APPROVED MINUTES OF THE MEETING

April 16, 2009

Bell Street Green Street Design
Artist Designed Bike Parking
New Bike Corrals
Seattle Trade Center Skybridge over Elliott
Pedestrian Master Plan
Grace Crunican, Director of SDOT
Children's Hospital Laurelon Street Vacation

1. BURKE-GILMAN TRAIL / SAND POINT WAY NE CONNECTION AT HARTMANN SITE

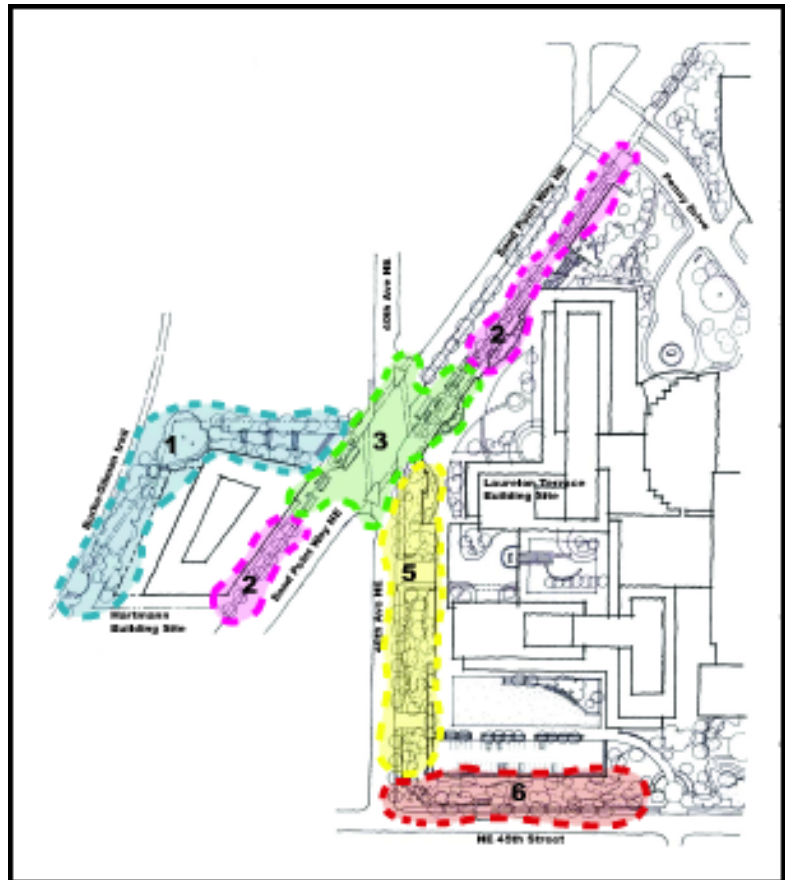
- Clear sight lines from Sand Point to the Burke Gillman trail will be developed.

The path going from the trail to the steps, what kind of material are you using?

I'm curious about the grade changes on the trail as you arrive at various nodes, does it drop significantly?

In regards to the kiosk, I'm a little concerned about the area at the bottom of the stairs. It looks to me like there are too many things at the bottom of the stairs including the kiosk, signage and artwork.

Will the trail connection be accessible?

It will be some type of asphalt or concrete

About 30' of drop from the NE corner to the SE corner of the site.

Our intention is to provide ADA accessibility from Sandpoint Way to the Burke Gillman Trail.
